Visual Impact Study

District of Columbia **CASE NO.16-23 EXHIBIT NO.213A1**

In response to the Commission's request, the following are additional views of the proposed Ladybird project. These views supplement Digital Design & Imaging Service's visuals contained as Exhibit 5 to Citizen for Responsible Development's Statement in Opposition (ZC Exhibit 137) and Digital Design's power point presentation at the January 25, 2018 hearing (ZC Exhibit 191). Specifically, we are including:

RE: Response to Valor Renderings replicating DDIS renderings (Exhibit 206B). Overview

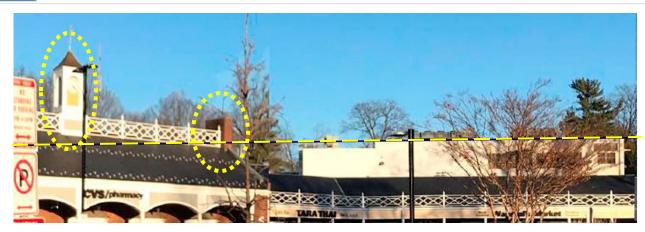
In addition to using a wide angle lens, the Valor photograph may then have been manipulated. The effect of this is to dramatically increase the existing height of the CVS roofline, minimizing the impact of the new proposed structure behind it. See the following visual evidence.

The above Valor photo has been altered by stitching together more than one image, or by stretching a section of the original photo. This manipulation creates inaccurate perspectives (compare with DDIS photo at bottom of the following page.)

Valor's Existing Image (P1 of 206B)

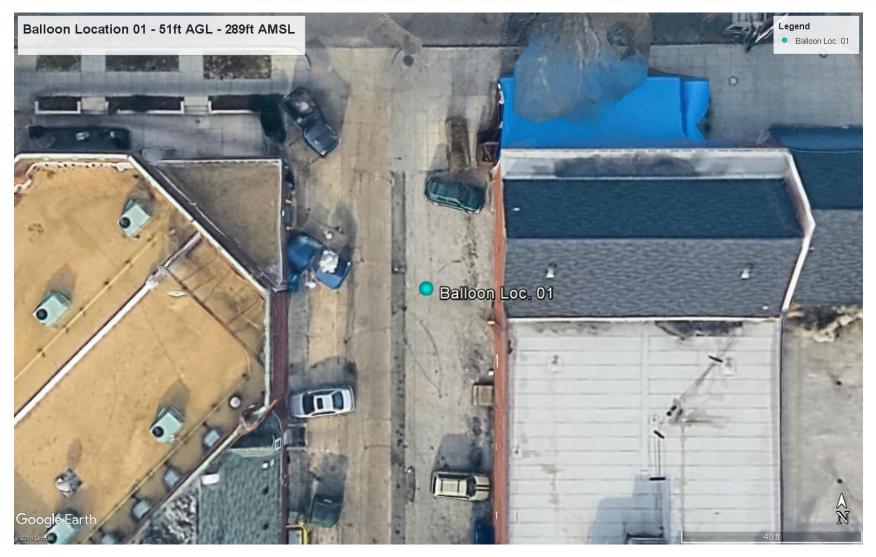
- Note the difference in height of the CVS building between Valor's image and DDIS' image. See how stretched (distorted) the clock tower and chimney appear in the Valor image. This is a result of using a wide-angle lens and then apparently manipulating the existing image in post-production.
- The photo manipulation of the base image alone should negate any credibility of the Valor rendering.
- Note that if the 37ft tall white existing warehouse roofline were extended North (left), it would disappear behind the CVS building, while staying visible behind the actual CVS, as captured in the DDIS scene. This result <u>artificially increases the height</u> of the CVS building, which causes Valor's rendering of the Ladybird building to appear much shorter. See Valor's rendering on page 20.
